Removing Odometer Pause Wiring Modifications

TSB-54-100-WST

Fig. 2, Allison OSS Sensor Wiring

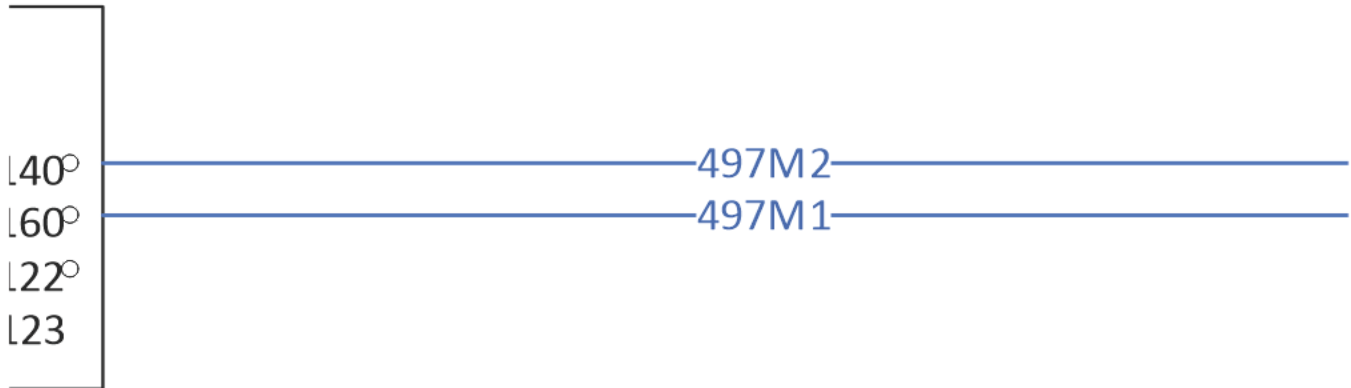
2. ☐ Remove both ends of 497M1 from the relay and connect 497M1 again. Leave the TCM pin 160 and the output speed sensor pin X3-4 intact. The final configuration is shown in Fig. 2.
